**To:** Doug Wise / Portland Water Bureau

**Date:** May 1, 2018

**Re:** Review of *Revised Well Decommissioning Work Plan, East Multnomah County Troutdale Sandstone Aquifer Remedy*, prepared by Geosyntec Consultants and dated April 2, 2018

Figure 1 - VOC and Groundwater Elevation at PWB-1-LTS

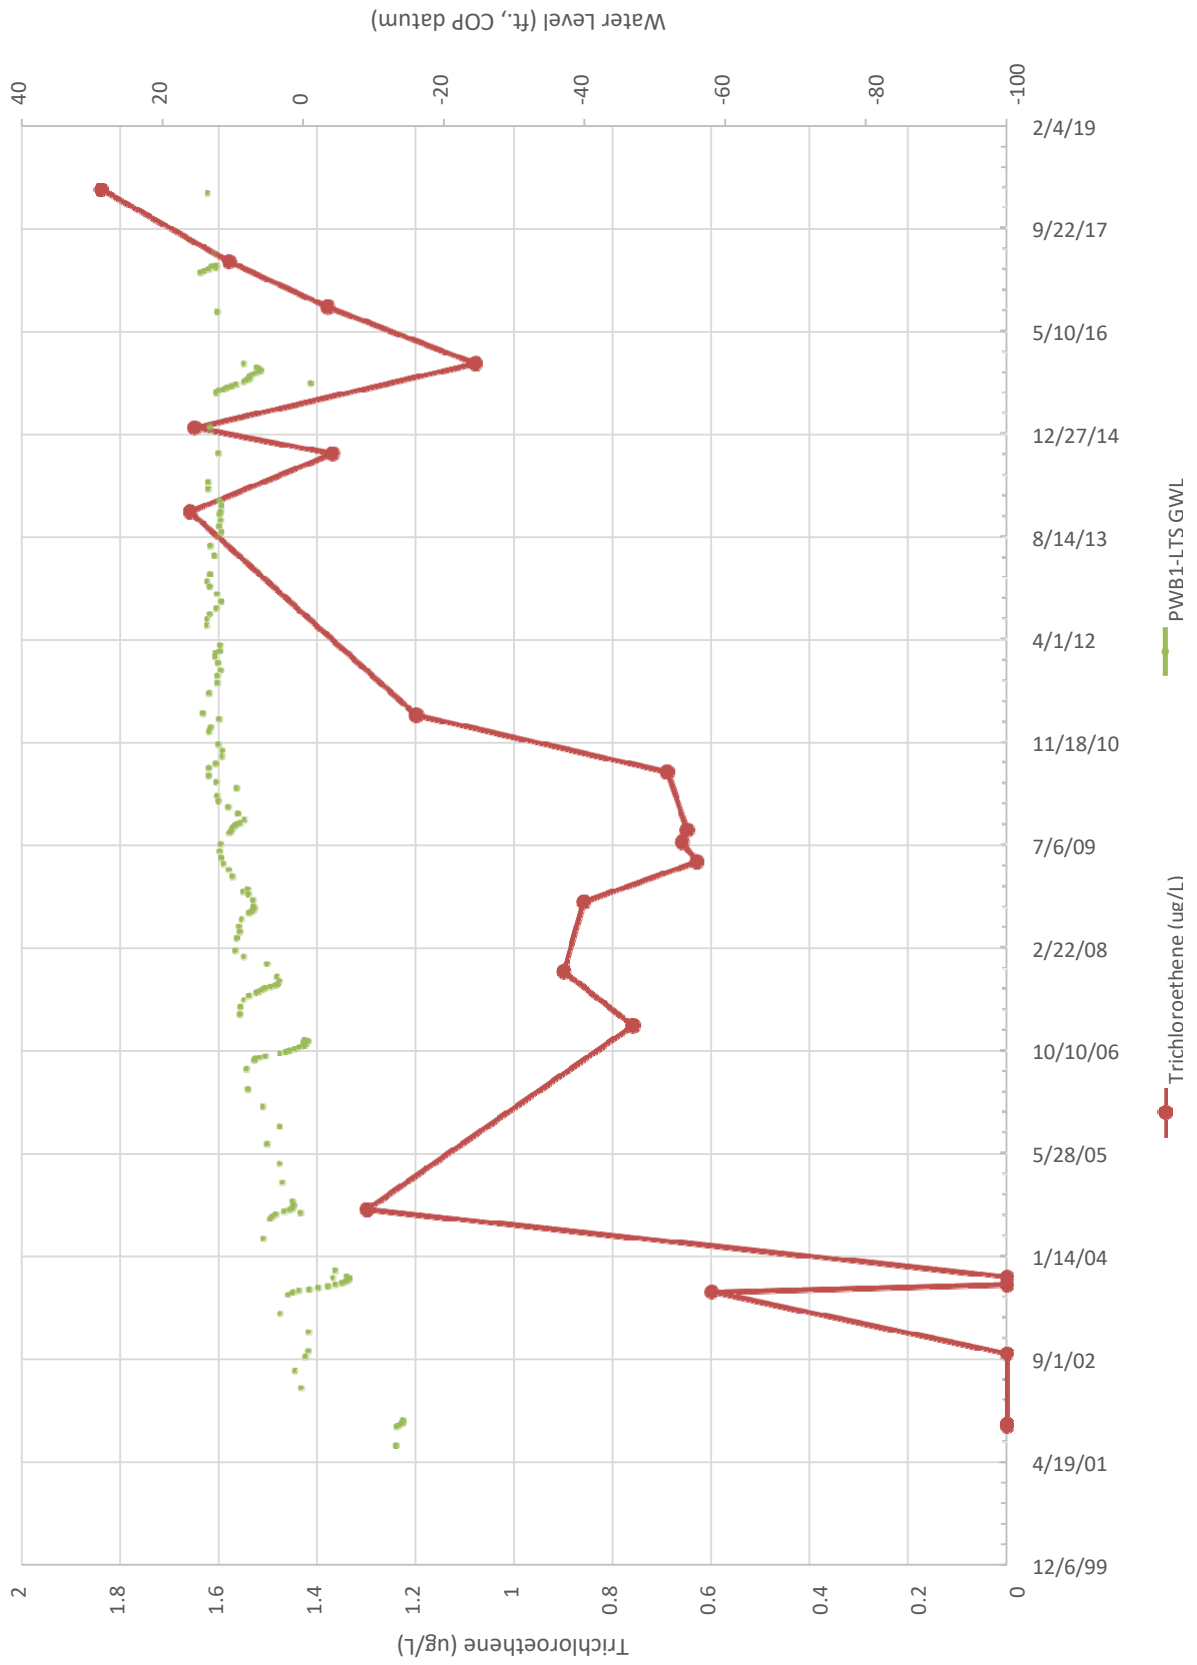
- Boeing/Cascade has not met the criteria to request decommissioning of BOP-70(ds), BOP-71(ds), D-16(dg) and RPW-1(ds) because confirmation samples have not been collected from these wells. The most recent groundwater samples from these wells were collected between four and twelve years ago. In that time, TCE concentrations measured by the Portland Water Bureau at monitoring well PWB-1-LTS have been increasing (Figure 1).

Portland Water Bureau sampling also detected TCE in PWB-1-UTS in 2018 for the first time since 2004 (Figure 2). Given the increasing TCE concentrations in PWB-1-LTS and re-emergence of detectable TCE at PWB-1-UTS, confirmation sampling is necessary to confirm that BOP-70(ds), BOP-71(ds), D-16(dg) and RPW-1(ds) still meet the criteria for monitoring well decommissioning that TCE remains below the MCL after the well was removed from the monitoring program.
